CLARENDON BRO 1443(48)
BRIDGE #11
ERECTION PLAN
Supplement to Address Review Comments Dated 6/15/16

RE: Walker Mountain Road Bridge Bridge #11
Rutland, VT
VTAOT Project # BRO 1443 (48)

LIFT LOOP DESIGN CALCULATIONS

Clarendon BRO 1443(48) Erection Plan Abutment #1 SK-1.0

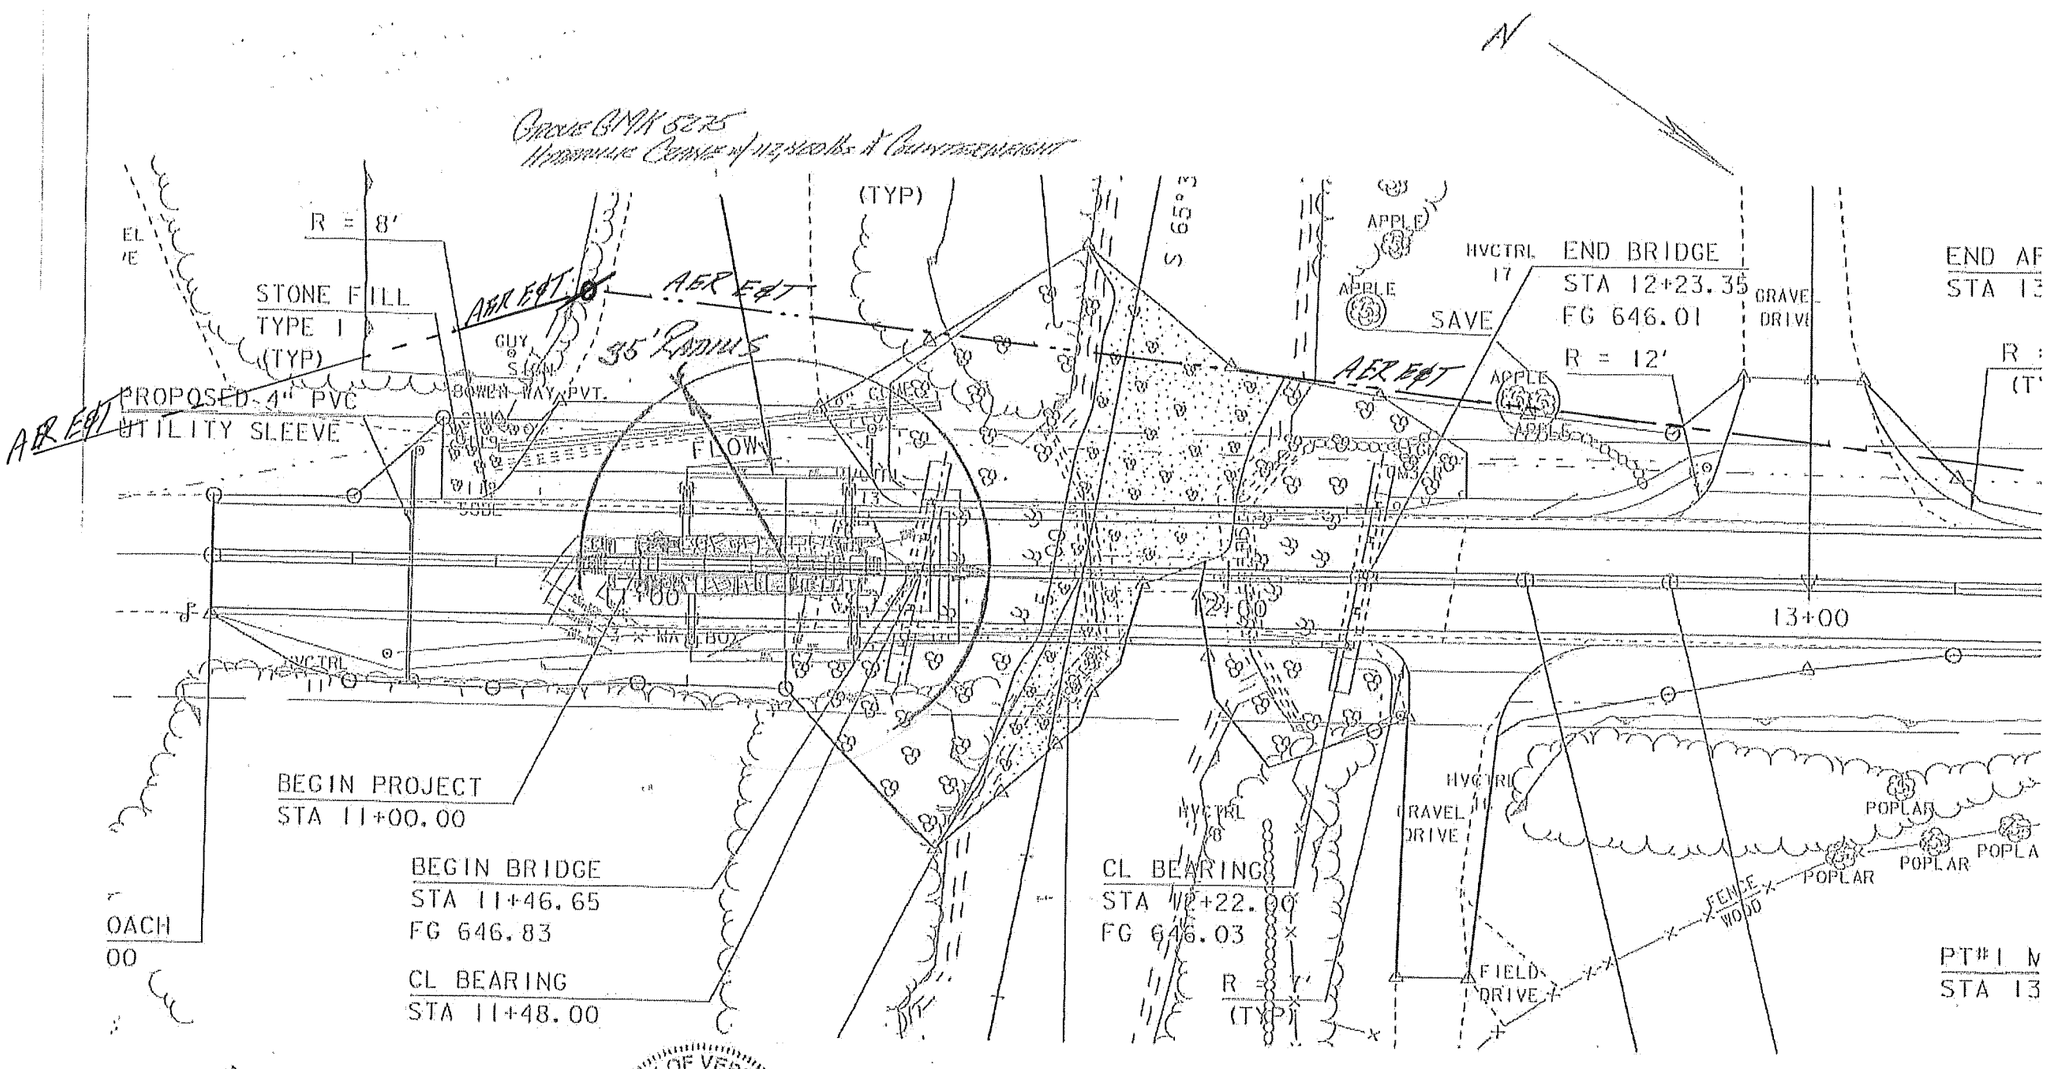
- *Show overhead utilities on plan sheets.* Relocated overhead utilities have now been shown on plans. Precast components shall be erected in accordance with OSHA regulations regarding separation. JA McDonald has confirmed with Green Mountain Power representative (Eric McLellan) the line voltage of the relocated overhead power lines of 7200 Volts.

Rev 1.0 – Show Overhead Utilities

SK-5

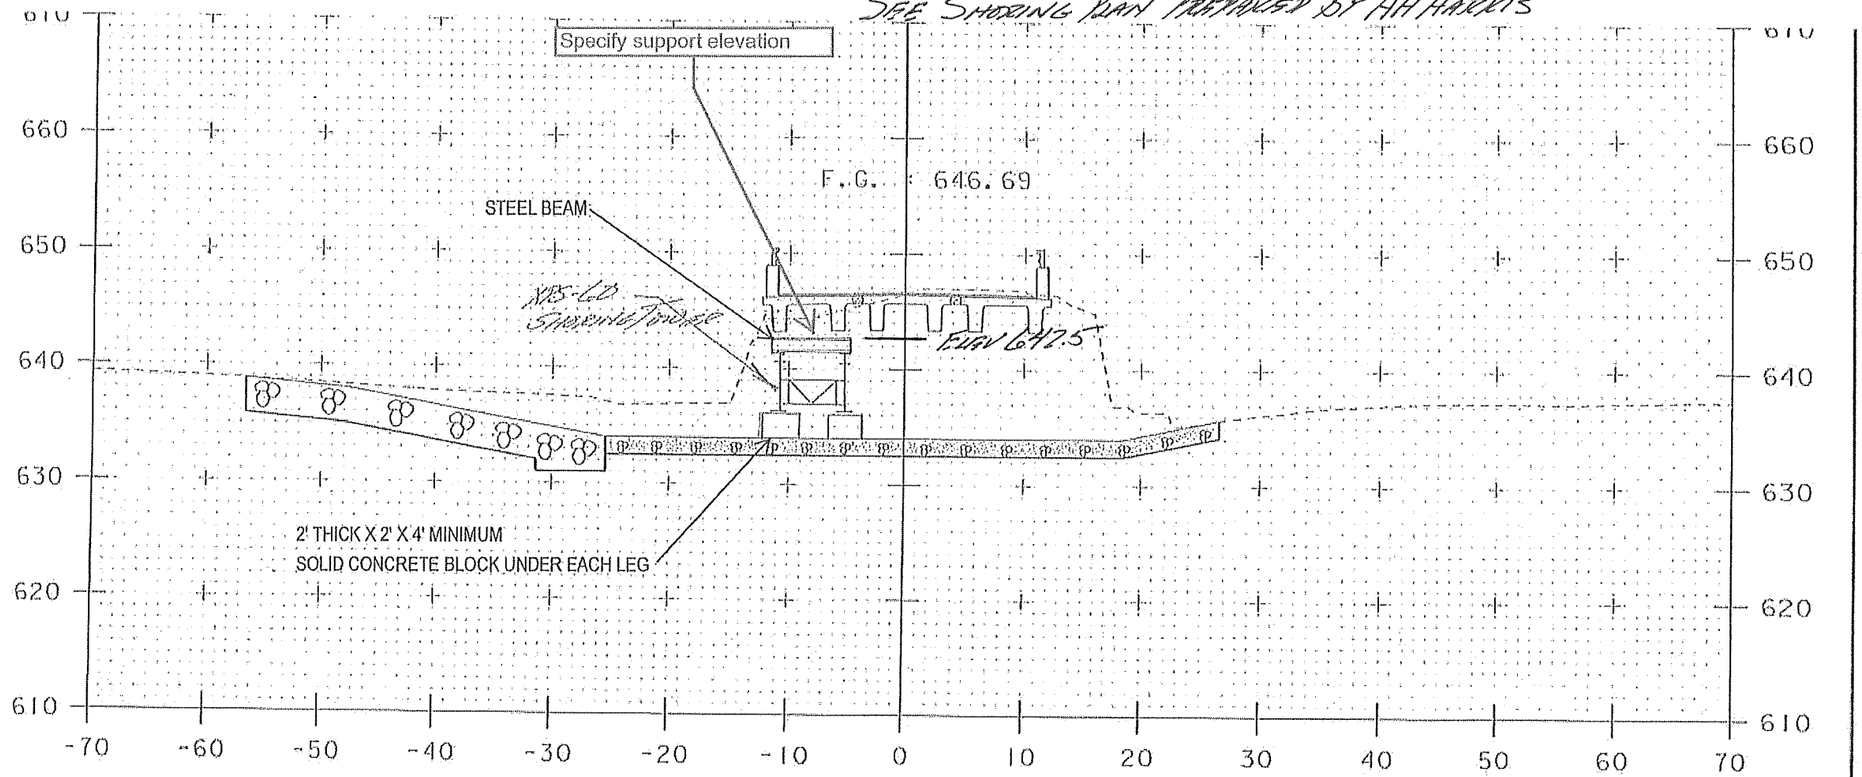
- *Specify support elevation.* The top elevation of the temporary shoring tower is 642.5 as noted on AH Harris Shoring Plan & Section. Elevation noted on Sketches SK-5 & SK-6

REV 1.0 SPECIFY SUPPORT ELEV.

SK-7

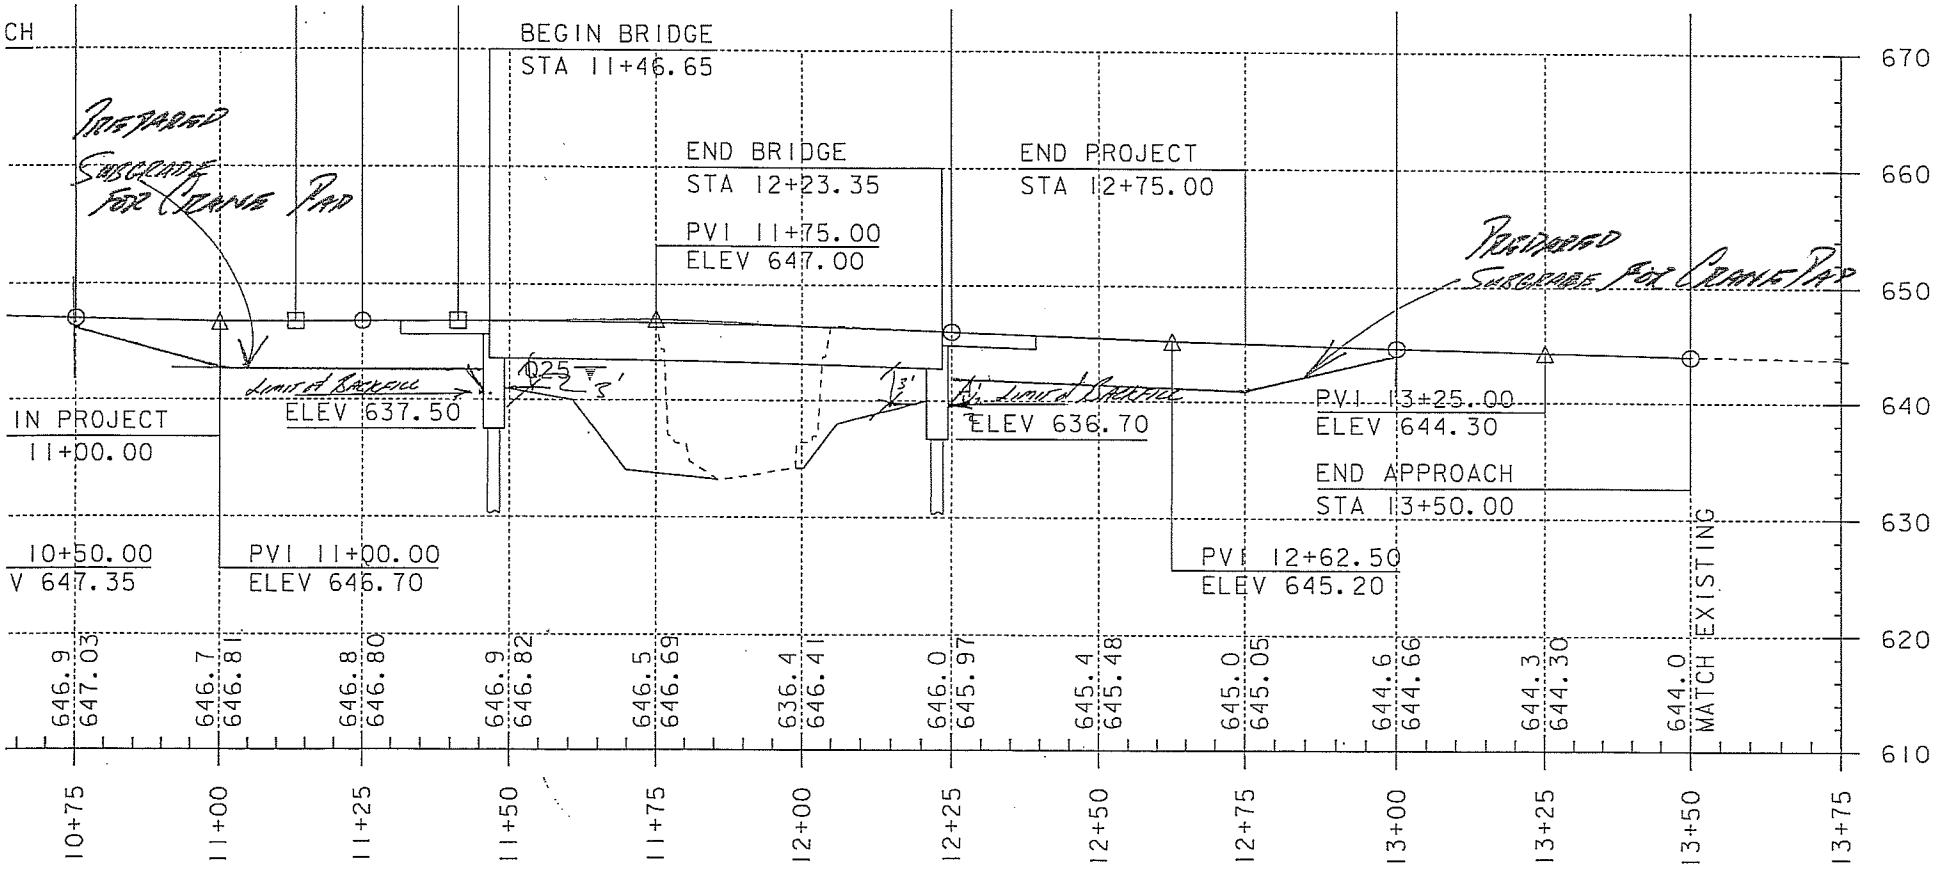
- *Per Contract Plans General Note 43 on Sheet 3/59, backfill shall be limited to the height of 3' below the bridge seat elevaction of the NEXT beams. This needs to be clear in the plan.* JA McDonald incorporates into its Erection Plan General Note 43 found on Sheet 3 of 59 which states: "The backfill behind the abutments shall be limited to a height of 3'-0" below the bridge seat and no cranes shall be closer than 1'-0" to the abutment during the erection of the superstructure" See attached Sketch SK-7

43. THE BACKFILL BEHIND THE ABUTMENTS SHALL BE LIMITED TO A HEIGHT OF 3'-0" BELOW THE BRIDGE SEAT AND NO CRANES SHALL BE CLOSER THAN 1'-0" TO THE ABUTMENT DURING THE ERECTION OF THE SUPERSTRUCTURE.

C-AB1 Abutment Elevation Schematic

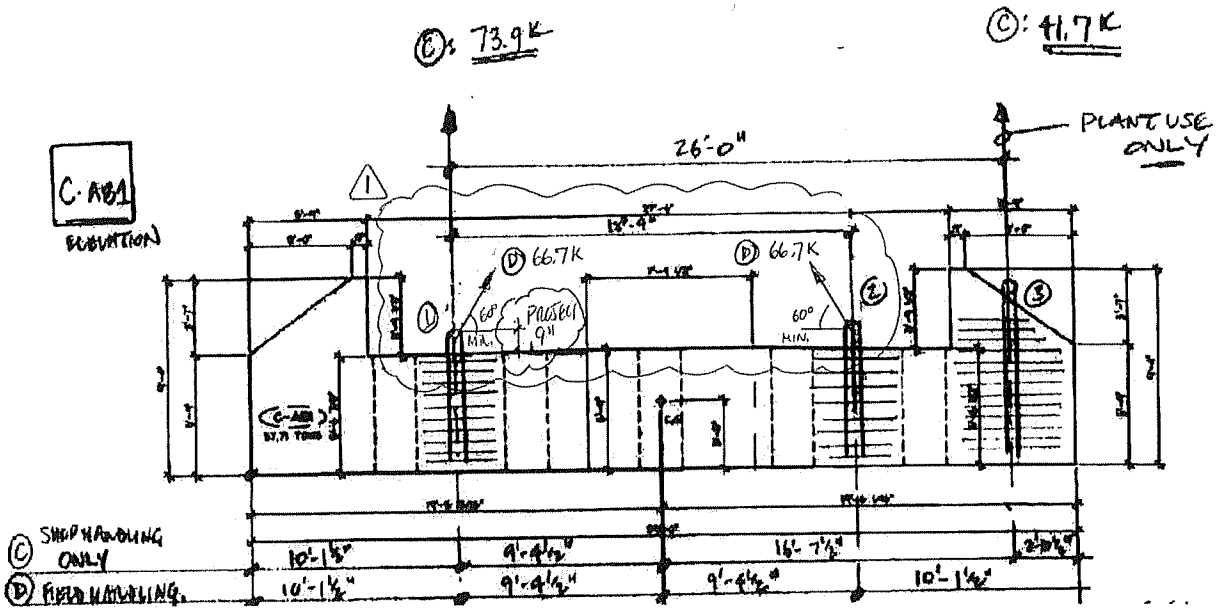
- *Abutment General Note #5 on Sheet C1 of the approved fabrication drawings states that vertical forces are to be applied to the lifting loops. The fabricator's lifting loop design for the abutments does not appear to account for horizontal lifting forces. If sling angles less than 90 degrees to the horizontal are required, provide documentation from the fabricator that this is acceptable with supporting design calculations stamped by a PE if necessary.* See attached documentation.

1 ORIGINAL $R_1 = R_2 = 57.8K$

$R_{1-60°} = R_{2-60°} = 57.8/0.866 = 66.7K$ EA (2) LOOPS
